SUNDRY NOTICES AND REPORTS ON WELLS

Pitchblende Fed Ut No. 2

30-025-27753

Conditions of Approval

**PROPOSED
WELLBORE SCHEMATIC**

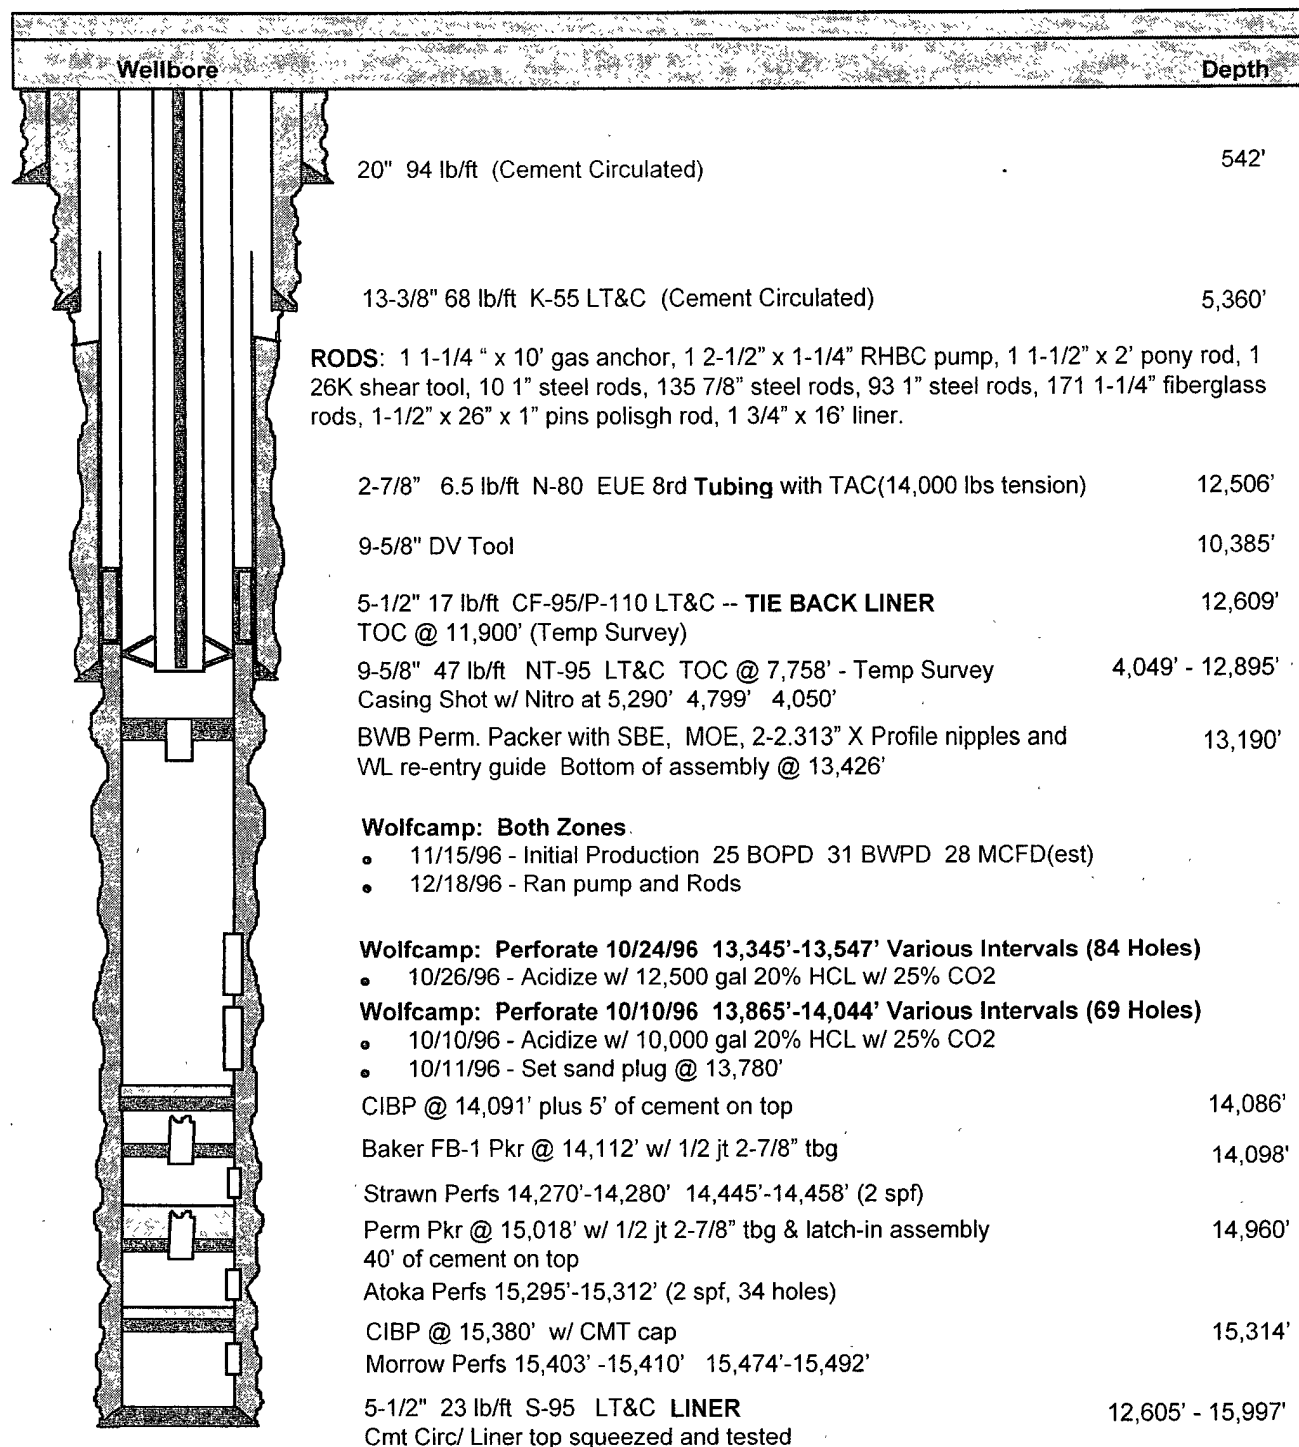
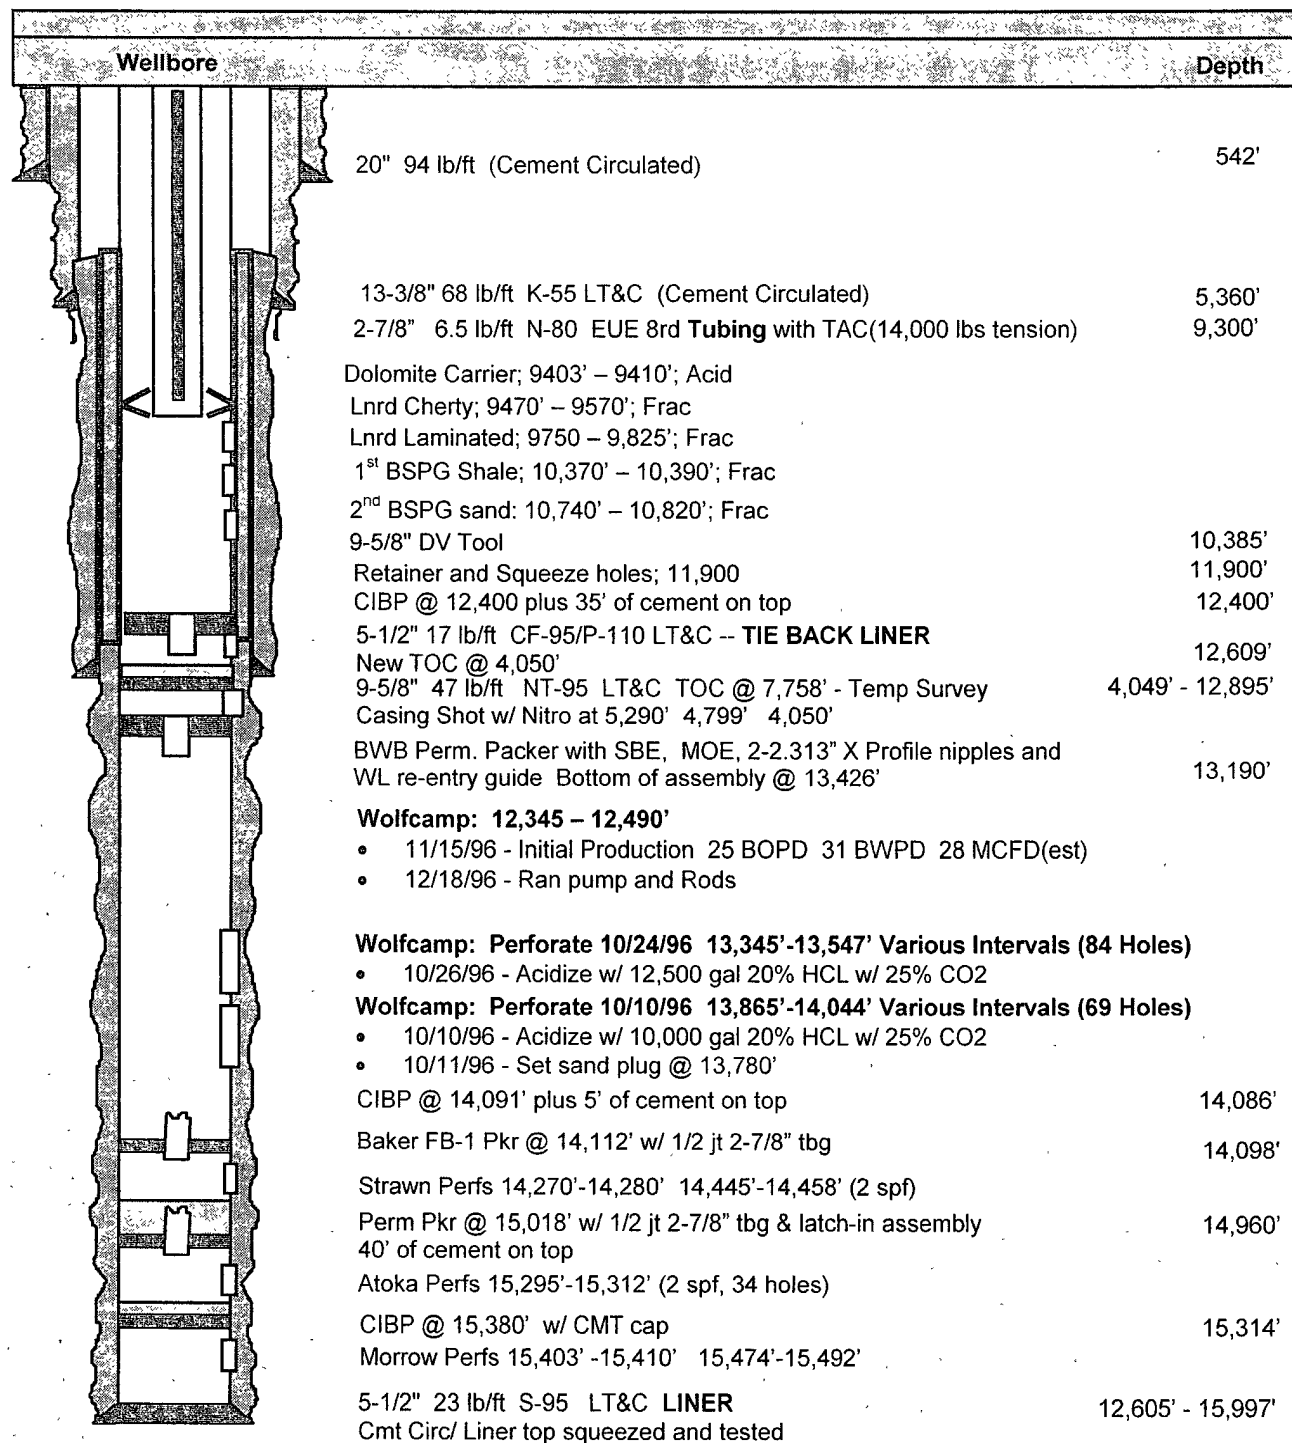
1. OK – Make sure rig has 5M BOP system that is set up and tested to Onshore Order 2 regulations and manufacturer recommendations.
2. OK
3. OK – Submit a copy of the CBL to the BLM. Results may result in changes to the COA.

- 3a. Drill out permanent packer at 13190'.
- 3b. Tag to verify CIBP with 5' of cement at 14086'
- 3c. Bail or dump 30' or pump 25sx of cement on top of CIBP.
The order in which the permanent packer is drilled out and the CBL is run isn't important. Just need to make sure both get done before step 4.

4. CHANGE: Set CIBP at 13275' + 35' cement bailed or dumped. (Perfs)
- 4a. Spot 230' plug (approx 30 sx) of Class H cement from 12945' to 12735'. WOC and tag at 12735' or shallower. (Csg Shoe)
OPTIONAL – Combine step 4 and 4a by spotting approx 55 sx on top of CIBP. WOC and tag at 12945' or shallower.

5. CHANGE: Set CIBP at 12330' + 35' cement bailed or dumped. (Wolfcamp – 3rd Bone Spring Sands/Wolfcamp Perfs)
- 5a. Set CIBP at 12035' and dump or bail 35' of cement on top. (Extra protection for the CIT – Added at request of the operator)

6. OK – PET from BLM must be present to witness test. If test fails, call BLM office for additional COA for replacing current casing.
7. OK
8. OK
9. OK – Submit a copy of the temperature survey to the BLM. Results may result in changes to the COA.
